Project	<b>IEEE 802.16 Broadband Wireless Access Working Group</b> < <a href="http://ieee802.org/16">http://ieee802.org/16</a> >	
Title	<b>Editorial Remedies related to the Credit Token based Coexistence Protocol</b>	
Date Submitted	<b>2006-11-10</b>	
Source(s)	David Grandblaise Motorola Labs Parc Les Algorithmes Commune de Saint Aubin 91193 Gif sur Yvette, France	Voice: +33 (0)1 6935 2582 Fax: +33 (0)1 6935 4801 mailto: <a href="mailto:david.grandblaise@motorola.com">david.grandblaise@motorola.com</a>
Re:	Working Group Review of Working Document P80216h_D1	
Abstract	This contribution provides some editorial text remedies for [1] on the credit token co-existence rental protocol section. This contribution is related to the comments #161, #171 and #174 provided in the review [2] corresponding to the IEEE 802.16 Working Group Letter Ballot #24.	
Purpose	Propose editorial text remedies in the credit token based co-existence protocol section (15.4.2.5).

# Editorial Remedies related to the Credit Token based Coexistence Protocol

Figure h47 - Example of TDD based MAC frame sharing structure between M systems

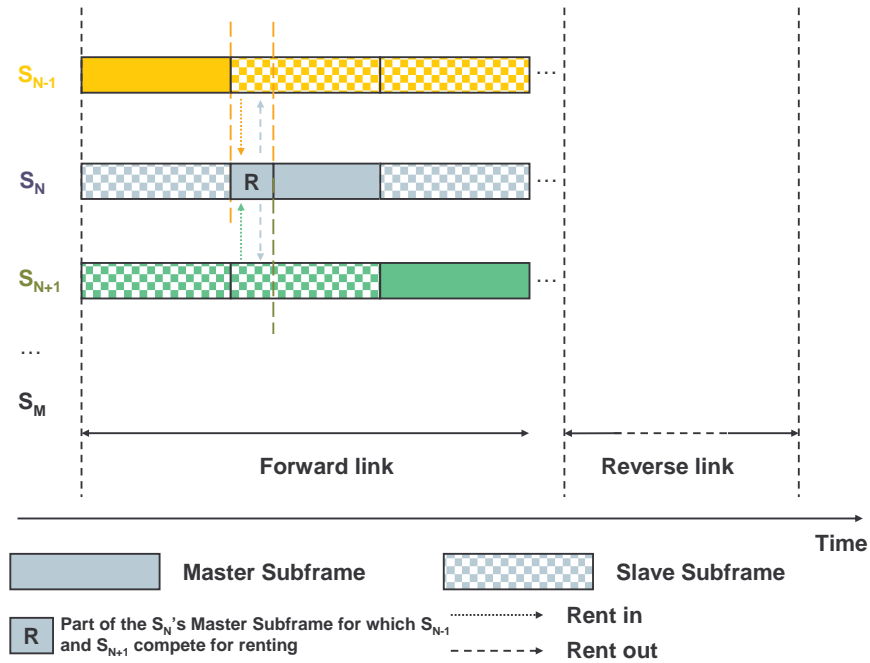
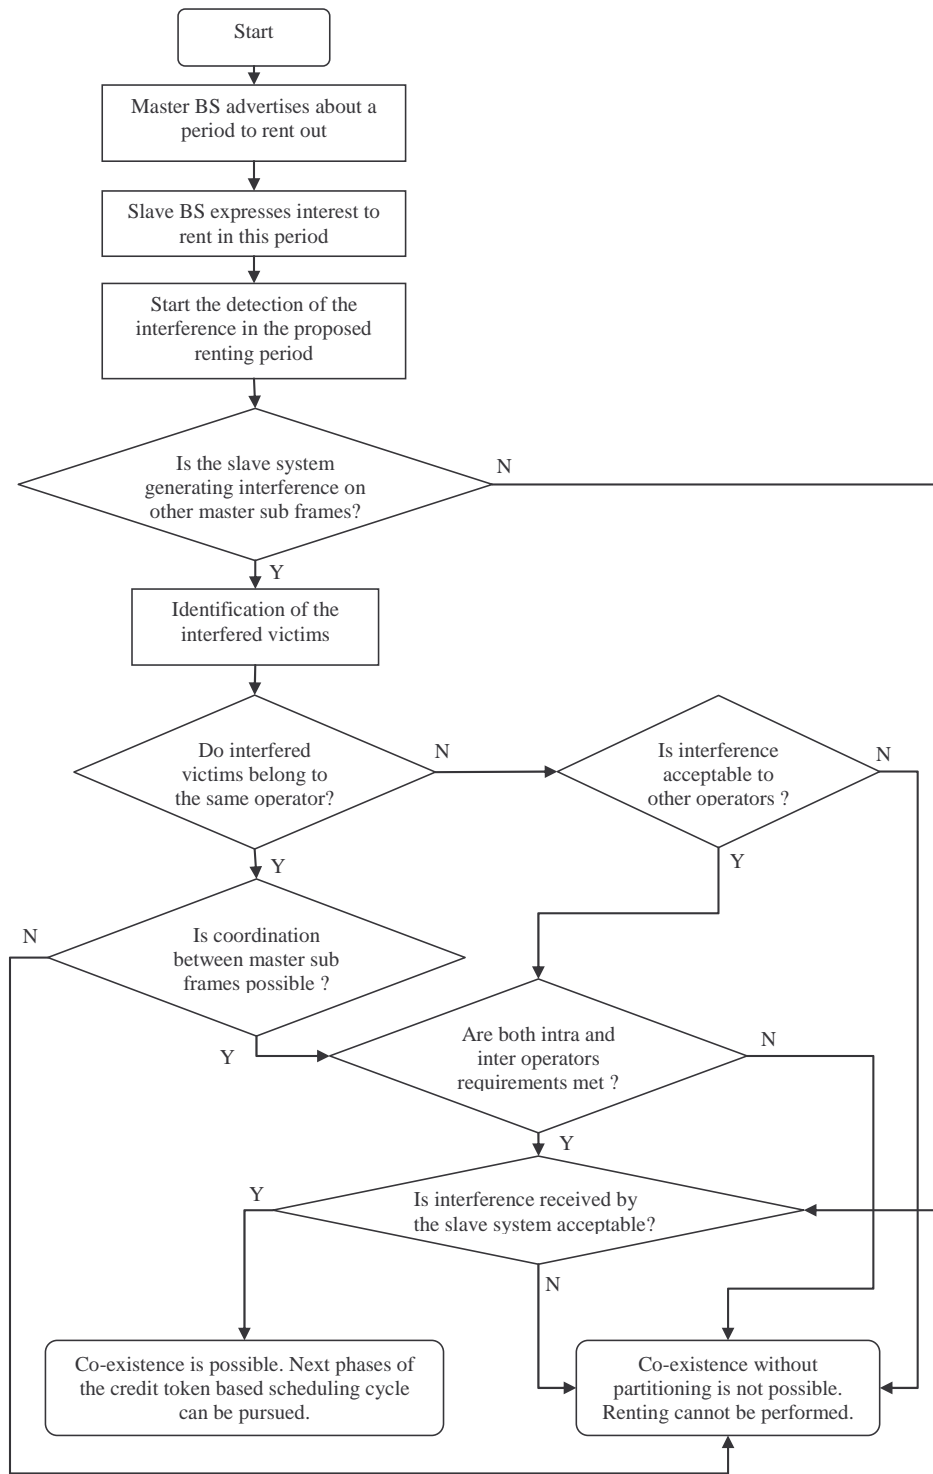
*Remove current Figure h47 and replace by the one below in the introductory text of section 15.4.2.5 (related to comments #161 of [2]).*
